UNITED STATES PATENT AND TRADEMARK OFFICE

APPLICATION NO.	FILING DATE	FIRST NAMED INVENTOR	ATTORNEY DOCKET NO.	CONFIRMATION NO.
10/658,306	09/09/2003	Nancy L. Saxon	60,130-1626; 02MRA0440	2157
26096	7590	01/05/2006	EXAMINER	
CARLSON, GASKEY & OLDS, P.C. 400 WEST MAPLE ROAD SUITE 350 BIRMINGHAM, MI 48009			ILAN, RUTH	
			ART UNIT	PAPER NUMBER
			3616

Office Action Summary

DETAILED ACTION

Fig. 10

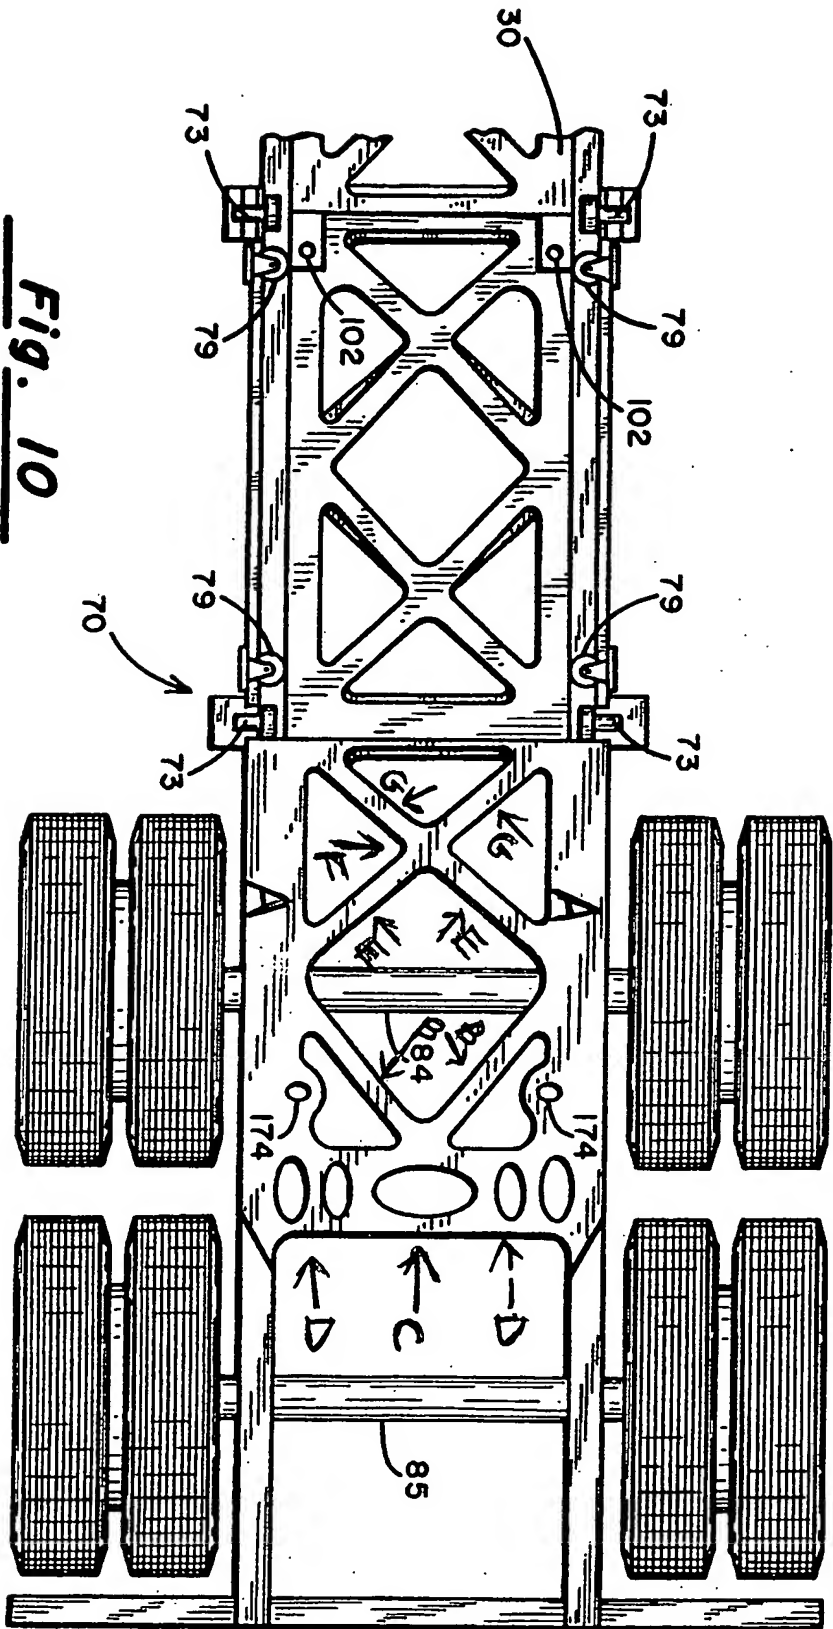
8. Claims 14, 16, 18, and 20 are rejected under 35 U.S.C. 102(b) as being anticipated by Christenson (US 5,067,740.) Please see the examiner annotated Figure 10 from Christenson. Christenson teaches a suspension slider (70) for a vehicle trailer (30) including first and second spaced apart longitudinal members (marked A in Figure 10) with a structure forming a continuous horizontal wall that interconnects the first and second longitudinal members and has first and second angled portions (B) converging to a central portion (C- portion of rear lateral member with central oval hole in it) and two lateral portions extending from the central portion (D- each of two sides of the lateral member with two oval holes each in them.) Regarding claim 20, third and fourth angled portions converge to a second central portion (F) and the second central portion has second lateral portions extending in opposing directions (G.)
